HEARING DATE: February 15, 2024

TO: Planning & Zoning Commission

FROM: Sonya Allen, Associate Planner  
208-884-5533

SUBJECT: Reveille Ridge Subdivision – AZ, PP  
[H-2023-0050](#)

PHASE MAP FOR  
 REVELLE RIDGE SUBDIVISION  
 LOCATED BY S 1/2 OF THE SE 1/4 AND THE N 1/2 OF THE SE 1/4  
 OF SECTION 2, T.2N., R.12E., E.M.  
 CITY OF MERRILL, ADA COUNTY, WYND  
 2020

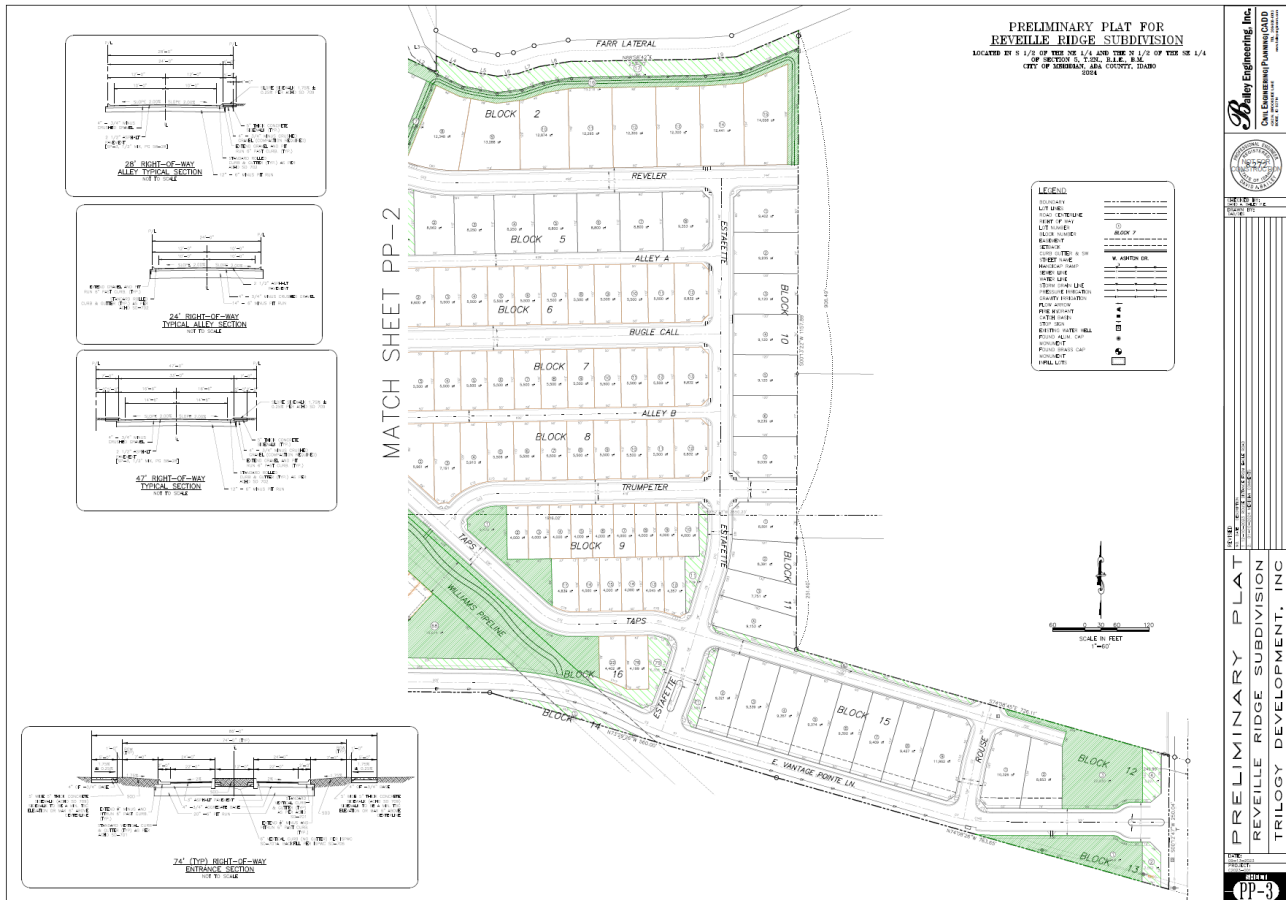
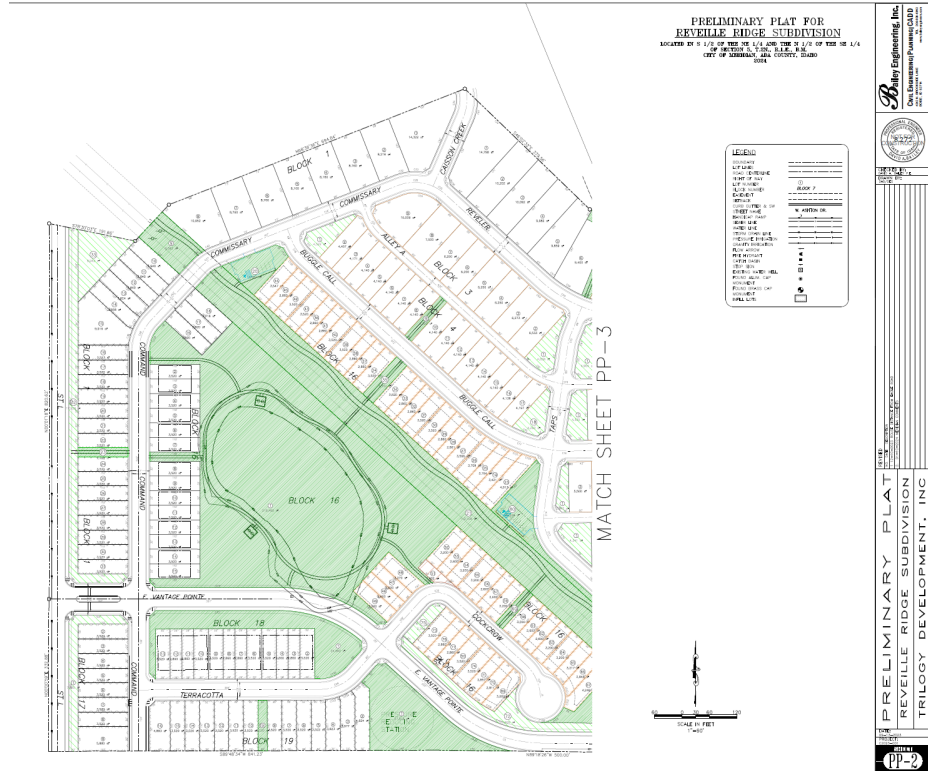
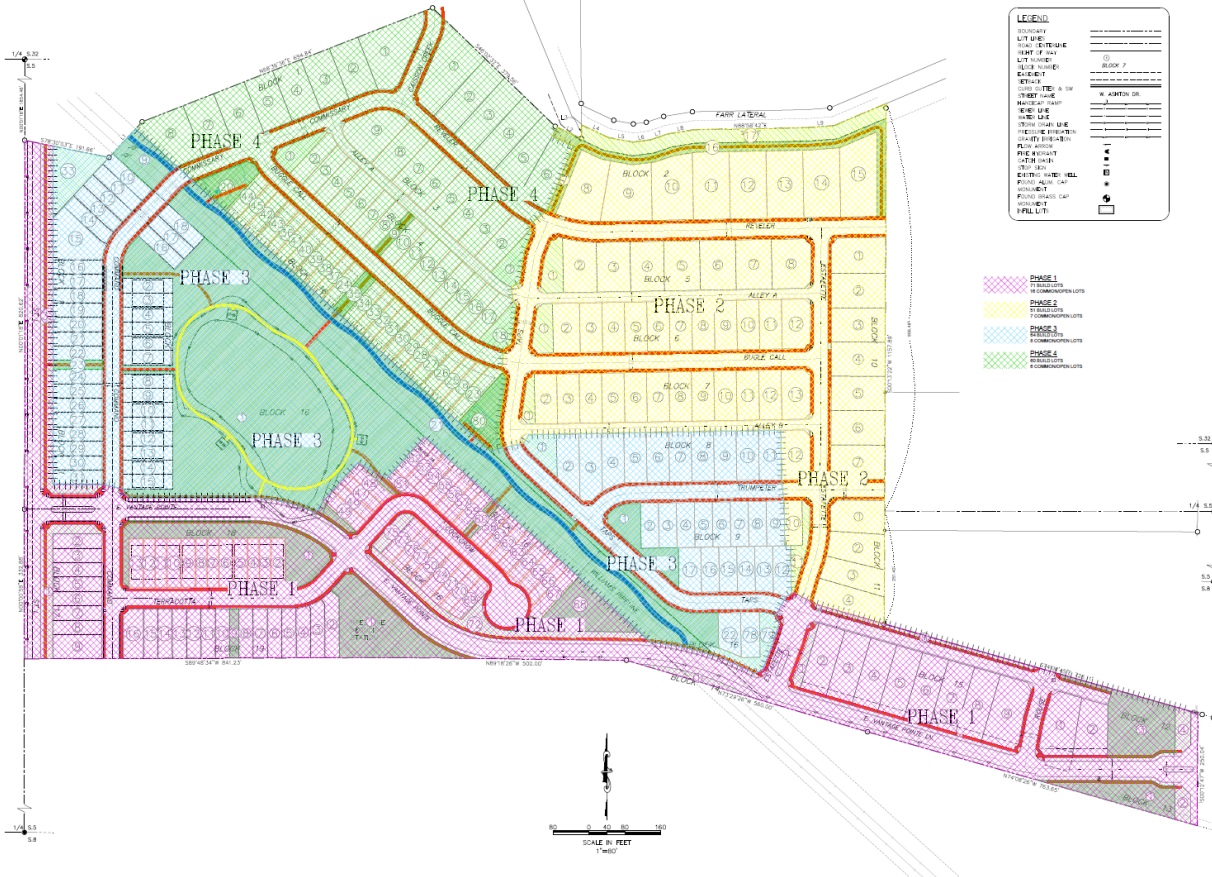
**Phasing Plan:** The subdivision is proposed to develop in four (4) phases per the phasing plan in Section VIII.B. The first phase is located along the southern boundary of the site and includes construction of all of the collector streets within the site. The second phase is the northeast portion of the development. The third phase is centrally located and contains the pond and most of the common open space for the development, including the linear open space in the Williams Pipeline easement. The fourth phase is the northwest portion of the development. **Staff recommends the phasing plan is revised to switch Phases 2 and 3 so the open space is provided in an earlier phase for the enjoyment of residents.**

11. Modify the phasing plan to switch Phases 2 and 3. Future development shall comply with the modified phasing plan.
12. An administrative design review application shall be submitted for the single-family attached and townhome structures to ensure compliance with the design standards listed in the Architectural Standards Manual.

C. Landscape Plan (dated: 12/12/2023)

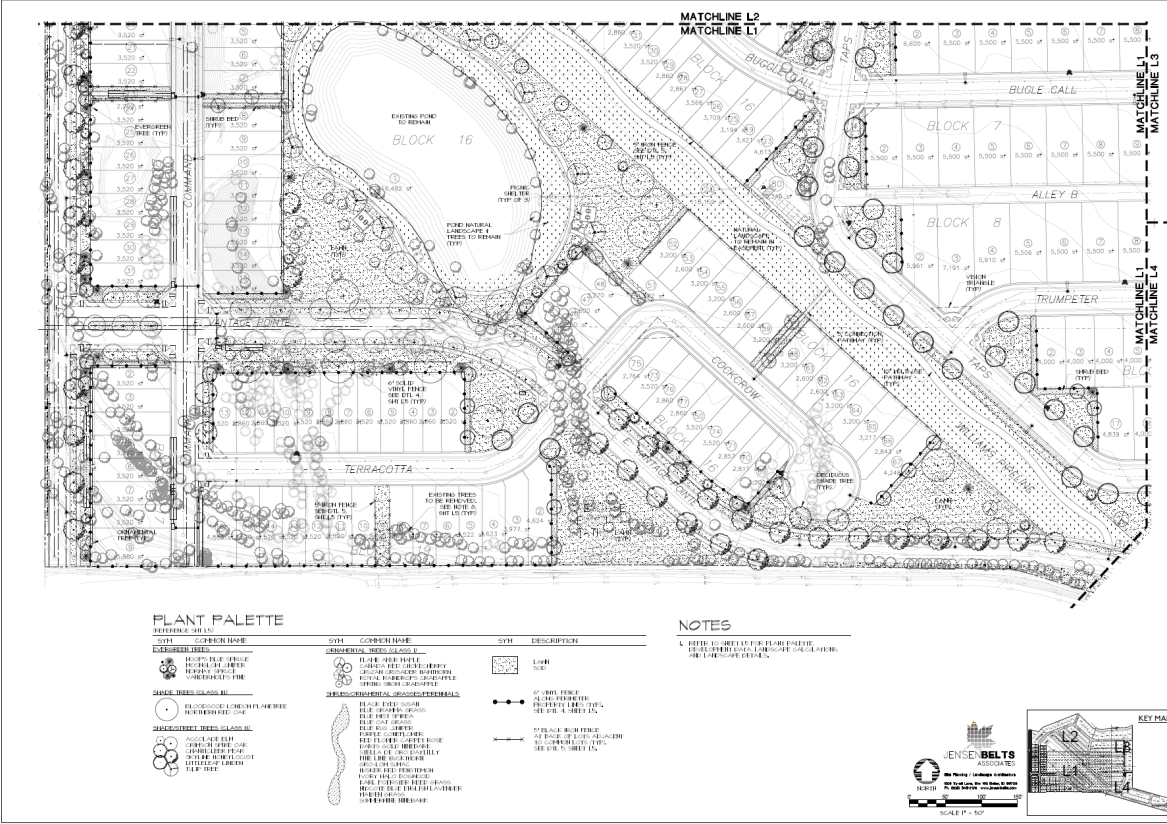
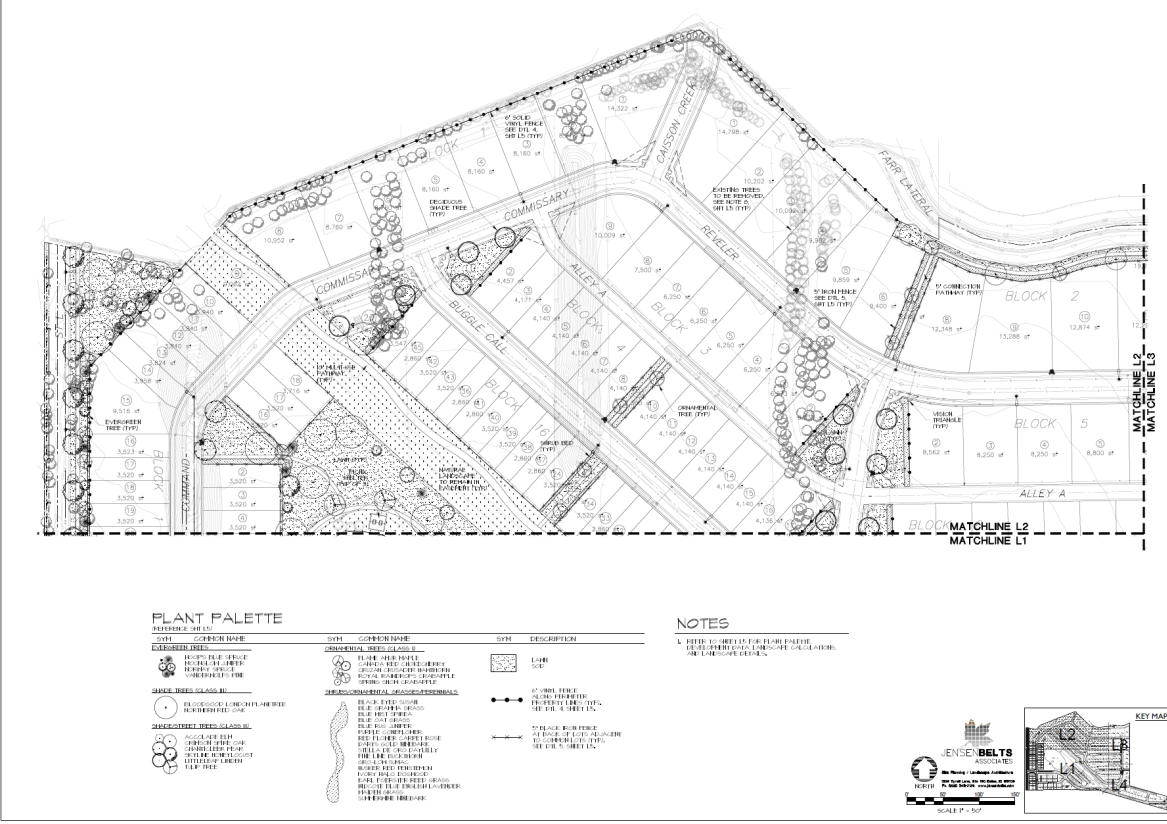
**Sidewalks/Parkways (11-3A-17):** For public safety, Staff recommends 10-foot wide detached sidewalks are provided along all collector and arterial streets within and adjacent to the site; parkways should comply with the standards listed in UDC [11-3A-17](#). The plat and landscape plan, should be revised accordingly.

**Landscaping:** A minimum 25-foot wide street buffer is required along S. Eagle Rd., an arterial street, measured from *ultimate* back of curb location; and 20-foot wide street buffers are required along E. Vantage Pointe and St L, collector streets, per UDC Tables [11-2A-6](#) and [11-2A-7](#). **The buffer along E. Vantage Pointe on Blocks 12 and 15 needs to be fully landscaped, including the area on the back side of the sidewalk. Landscaping is required within the street buffers and parkways in accord with the standards listed in UDC [11-3B-7C.3](#); the landscape plan should be revised to include a mix of landscaping materials and a calculations table that demonstrates compliance with the standards. All street buffers should be in a common lot or on a permanent dedicated buffer easement maintained by the property owner or homeowner's association; street buffers should be depicted on the plat accordingly and labeled as such.**

**Landscaping, including trees and shrubs, should be depicted on the landscape plan within the 5' wide landscape strip on each side of all pathways as set forth in UDC [11-3B-12C](#). Note: Alternative compliance may be requested for the trees along the pathway in the Williams pipeline easement as set forth in UDC [11-5B-5](#).**

**There are several existing trees on the site – where possible, existing trees should be retained. Mitigation is required in accord with the standards listed in UDC [11-3B-10C.5](#); calculations demonstrating compliance with the aforementioned standards should be depicted on the landscape plan.**

**Fencing:** All fencing is required to comply with the standards listed in UDC [11-3A-6C](#) and [11-3A-7](#), as applicable. The landscape plan depicts a mix of 6’ tall vinyl privacy fencing and 5’ tall wrought iron fencing.

**Because there is a common lot with a pathway planned in Vertex Subdivision along the northern boundary of the site, Staff recommends the fencing in this location is changed to 5’ tall wrought iron fencing to match that on the north side of the pathway and that proposed on this site to the east along the Farr Lateral in accord with UDC [11-3A-7A.7b](#).**

- i. Depict a 10-foot wide sidewalk along one side of Taps to between the Williams pipeline pathway and the Farr Lateral pathway.
3. The landscape plan submitted with the final plat shall include the following revisions:

- g. Change the fencing type along the northern boundary on the western portion of the site adjacent to the common open space with a pathway in Vertex Subdivision to 5-foot tall wrought iron fencing in accord with UDC [11-3A-7A.7b](#).

- j. Include a detail for the picnic areas on Lot 1, Block 16 that includes tables, benches, landscaping and a structure for shade to demonstrate compliance with UDC [11-3G-4C.5](#).

- m. Depict a 5-foot wide landscape buffer planted with shrubs, lawn or other vegetative groundcover along the southwest side of the common driveway on Lot 51, Block 16 in accord with UDC [11-6C-3D.5](#).

E. Conceptual Building Elevations

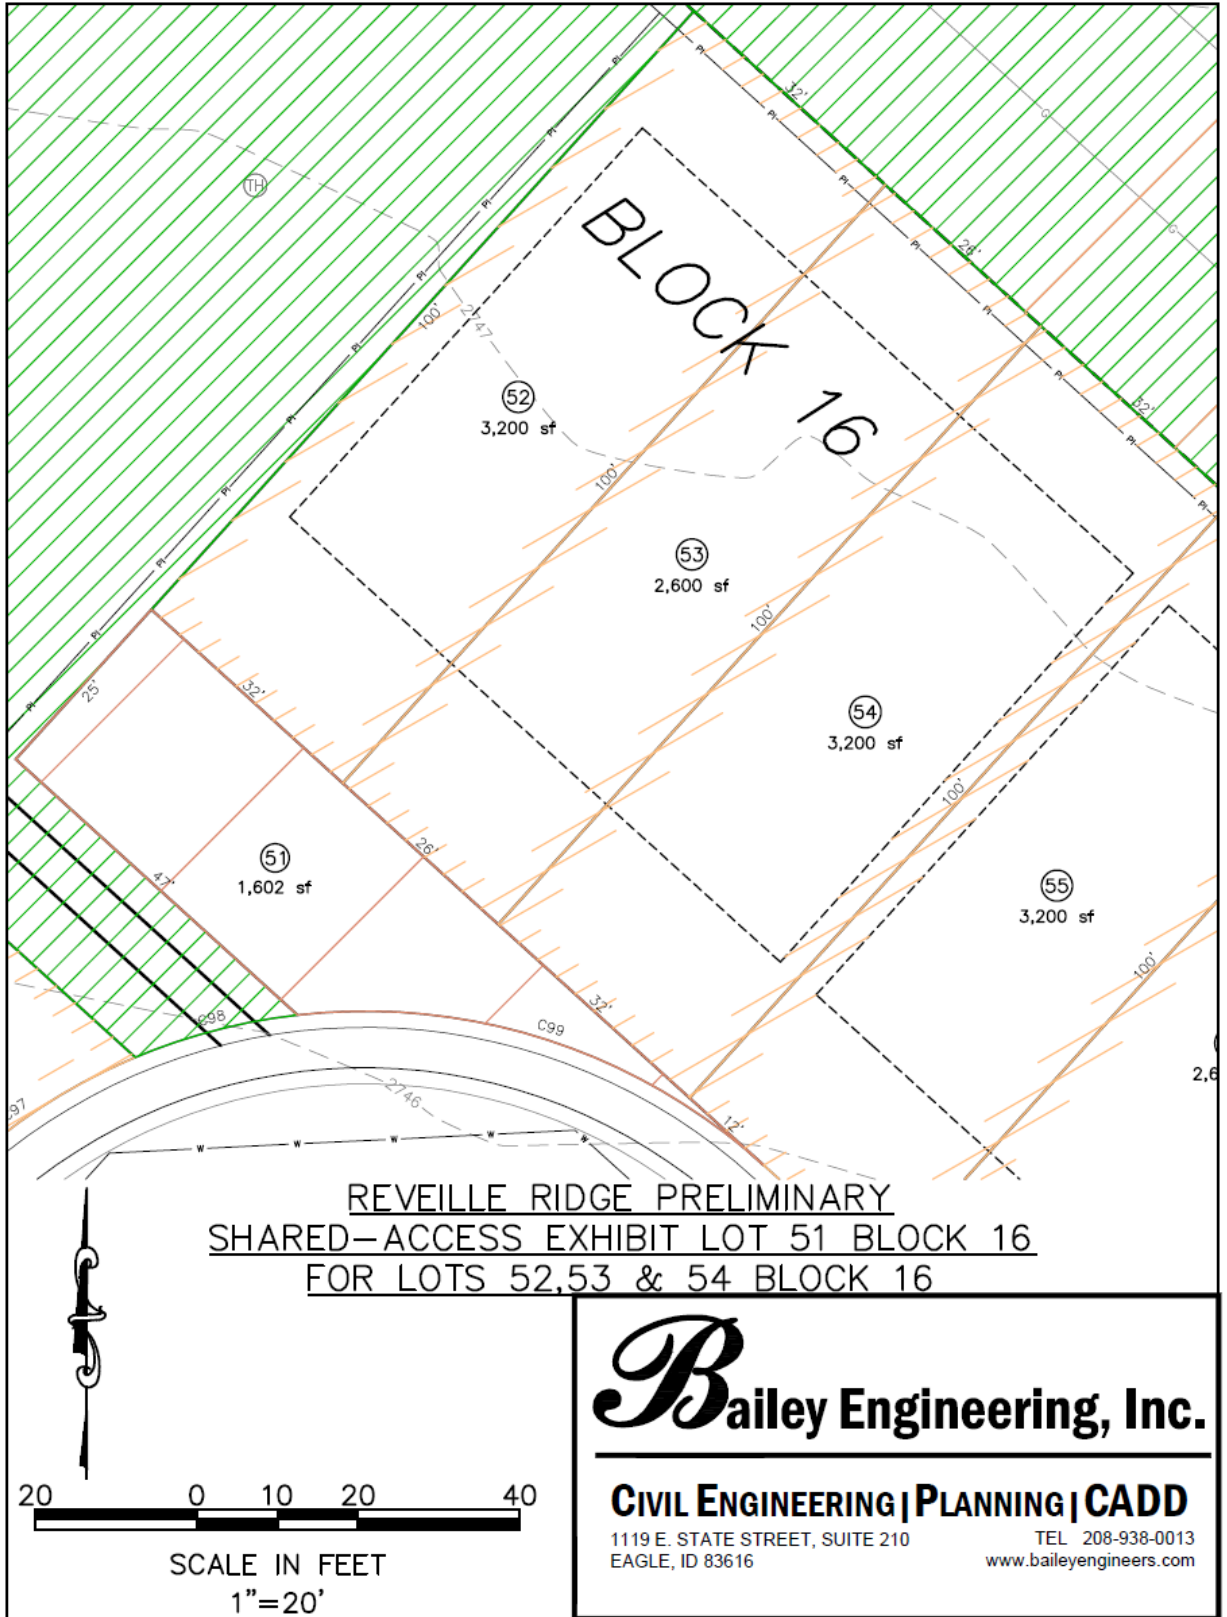
**Because homes on lots that face collector (E. Vantage Pointe & St L) and arterial (S. Eagle Rd.) will be highly visible, Staff recommends the rear and/or sides of structures facing these streets incorporate articulation through changes in two or more of the following: modulation (e.g. projections, recesses, step-backs, pop-outs), bays, banding, porches, balconies, material types, or other integrated architectural elements to break up monotonous wall planes and roof lines that are visible from the subject public streets.**

- c. The rear and/or sides of homes on lots that face collector (E. Vantage Pointe & St L) and arterial (S. Eagle Rd.) streets shall incorporate articulation through changes in two or more of the following: modulation (e.g. projections, recesses, step-backs, pop-outs), bays, banding, porches, balconies, material types, or other integrated architectural elements to break up monotonous wall planes and roof lines that are visible from the subject public streets.
